YEAR 1991 - 95 **NEW** MODEL LEGEND

BULLETIN NO. **91-045**

Erratic Remote Audio Control Operation

(Supersedes 91-045, dated September 29, 1992)

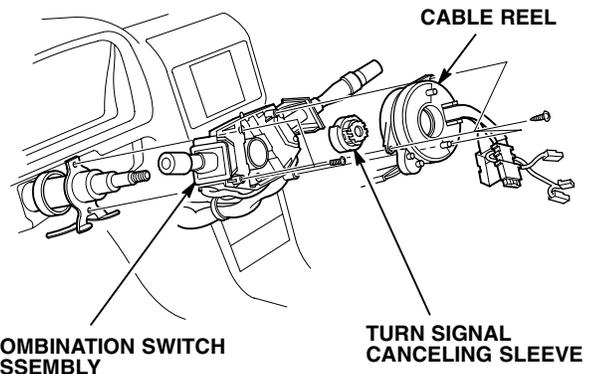
Install the slip ring assembly listed under PARTS INFORMATION to improve grounding of the steering shaft. Refer to section 17 of the appropriate service manual.

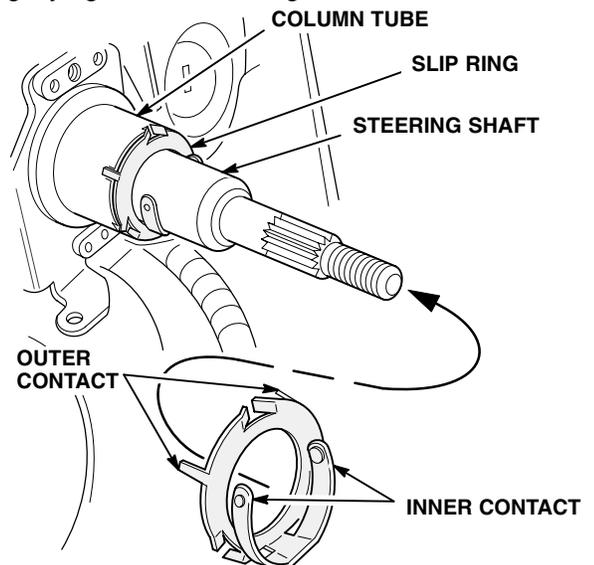
6. Remove three mounting screws, then remove the cable reel. Let the cable reel hang from the wire harness.

7. Remove the turn signal canceling sleeve.
8. Remove two mounting screws, then remove the combination switch assembly. For easier removal, angle it toward the passenger's side. Lay the assembly on the floor of the car, do not disconnect it from the wire harness.
9. Install the steering shaft slip ring as shown. The straight-cut edge of the slip ring should be on the bottom. Make sure the outer contacts fit tightly against the column tube and the inner contacts fit tightly against the steering shaft.
